Connecting Cabra CBC05 BusConnects Observation (Case: 313892)

1.0 Introduction

Figure 2 Schematic of Navan Rd, Cabra Rd, Old Cabra Rd & Ratoath Rd Junction.

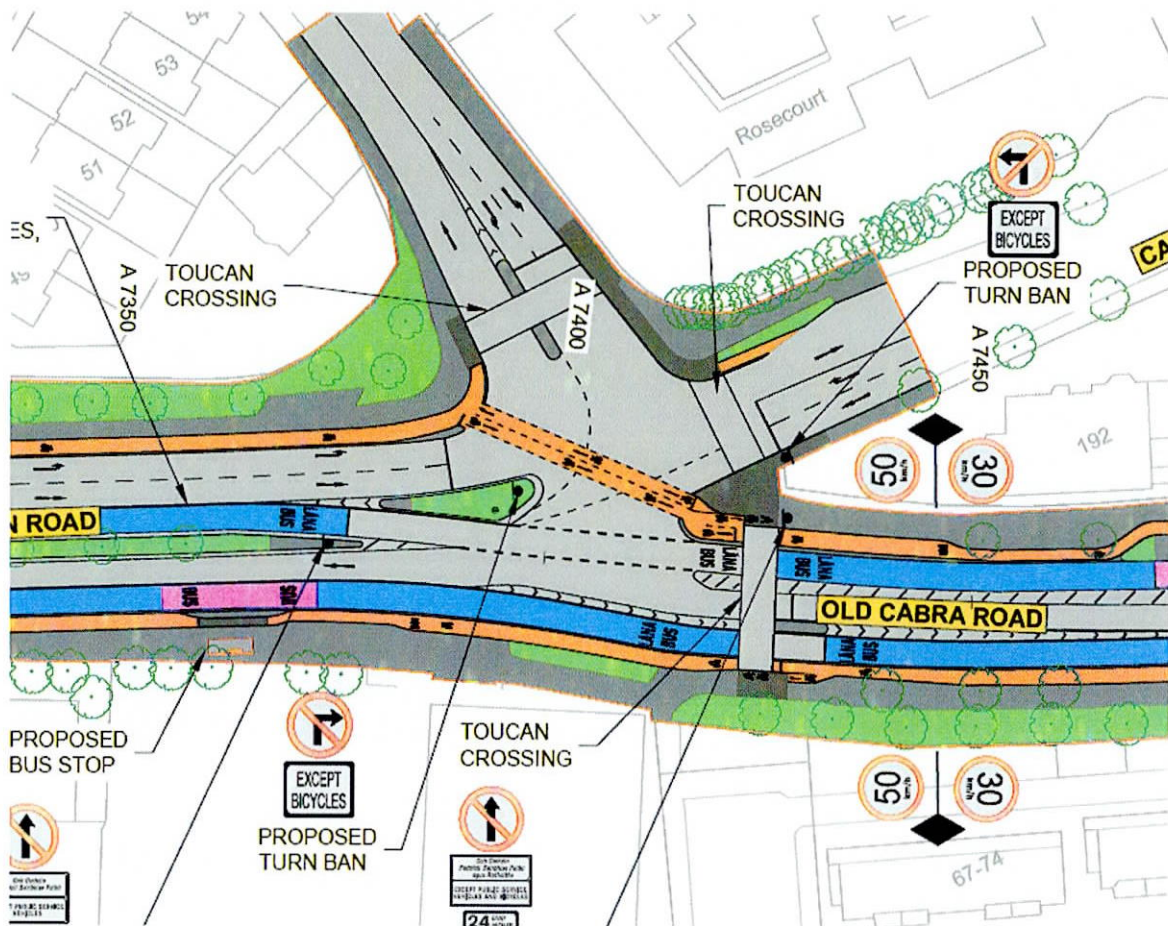
There are serious shortcomings in fulfilling a fundamental design principle of cycling infrastructure: **Legibility (National Cycling Manual 4.4.1.2 Principles of Sustainable Safety)**. Cyclists proceeding from the Navan Rd to the Eastbound (R147) cycle lane do not have a clear and legible path to continue cycling to the Cabra Rd (R147). Cyclists are forced to stop and wait at a Toucan crossing to continue onto Cabra Rd (R147). This is to facilitate left turning vehicular traffic. A clear, legible lane should be developed to facilitate the movement of cyclist continuing straight from Navan Rd to Cabra Rd (R147).

Figure 4 Survey results from Connecting Cabra Survey of residents on Cabra Road (R147)

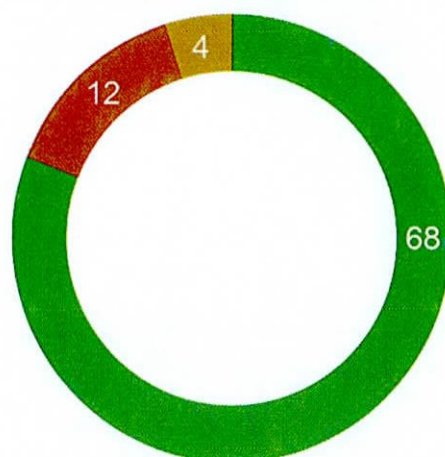
Connecting Cabra surveyed everyone on the Cabra Road (R147). All 120 houses, between Clarke’s Bakery and McDonald’s restaurant, were surveyed about whether they’d support protected cycle lanes on their road.

70% responded with 81% in favour.

Many businesses on the street, local councillors and resident’s groups in the area support this infrastructure too. The road is 9.6 metres wide. It is sufficiently wide to accommodate to DMURS standard cycle lanes without discommoding existing traffic.

Figure 6 Left schematic showing wide corner radii on Swilly Rd. Right schematic showing smaller corner radii on Charleville Rd

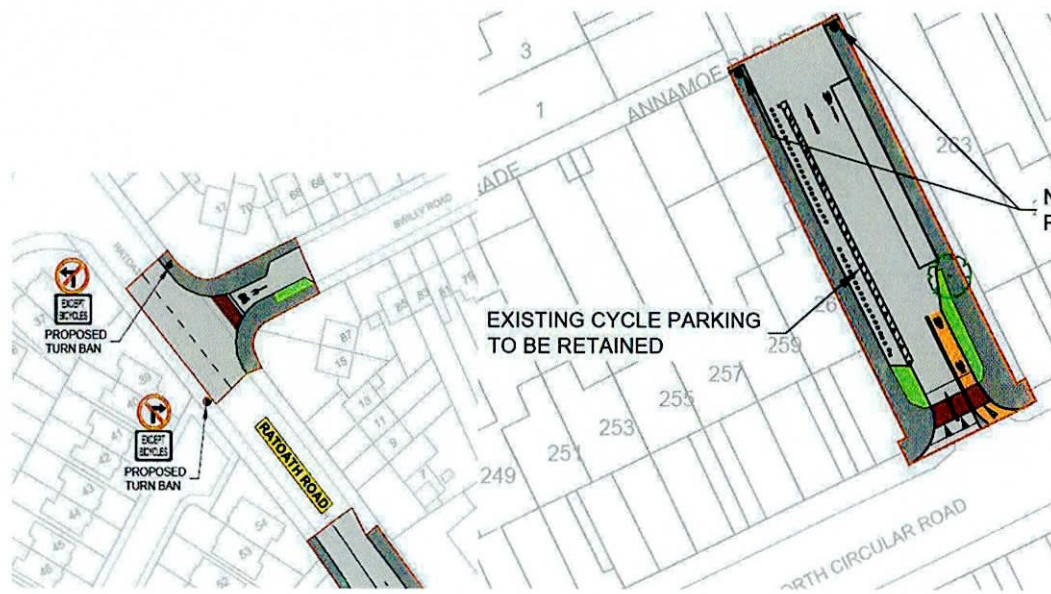
The corner radii on Swilly Rd & Ratoath Rd junction should be significantly reduced, and align with corner radii on Charleville Rd and North Circular Rd (see Figure 6 for comparison), as per DMURS Section 4.3.3 Corner Radii

The substantial corner radii proposed is a danger to pedestrians and cyclist whilst it encourages drivers to take the corner at speed. Supported by DMURS 4.3.3 Corner Radii:

“Where turning movements occur from an Arterial or Link street into a Local street corner radii may be reduced to 4.5m.”
